Project	IEEE 802.16 Broadband Wireless Access Working Group http://ieee802.org/16 Clarification of renumbering and permutation based on DL_PermBase parameter	
Title		
Date Submitted	2005-05-04	
Source(s)	Sean Cai Jason Hou Liujun Hu	scai@ztesandiego.com jhou@ztesandiego.com
	ZTE San Diego Inc. 10105 Pacific Heights Blvd. San Diego, CA 92121 USA	Voice: 858-554-0387 Fax: 858-554-0894
	Lei Wang Cygnus Multimedia Communications, Inc.	Email: lwang@cygnuscom.com
		Voice (760)448-1984 Fax: (760)448-1989
	Yossi Segal Runcom Ltd.	yossis@runcom.co.il Voice:+972-3-9528440 Fax:+972-3-9528805
Re:	IEEE 802.16 WG Recirculation Ballot #17a on P802.16-2004/Cor1/D2	
Abstract	This contribution is for clarification of renumbering and permutation based on DL_PermBase parameter	
Purpose	To incorporate the text modification proposed in this contribution into P802.16-2004/Cor1/D3.	
Notice	This document has been prepared to assist IEEE 802.16. It is offered as a basis for discussion and is not binding on the contributing individual(s) or organization(s). The material in this document is subject to change in form and content after further study. The contributor(s) reserve(s) the right to add, amend or withd

Figure 219-Illustration of OFDMA frame with multiple zones

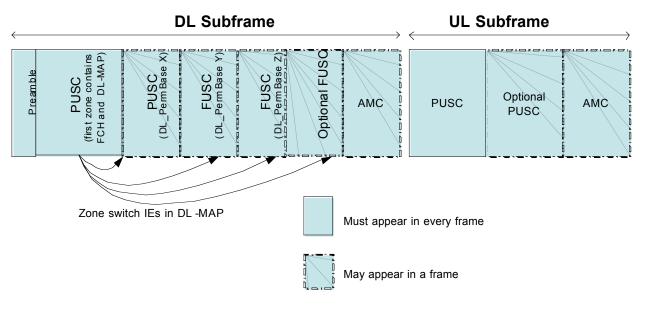
[Replace Figure 219 with the following figure:]
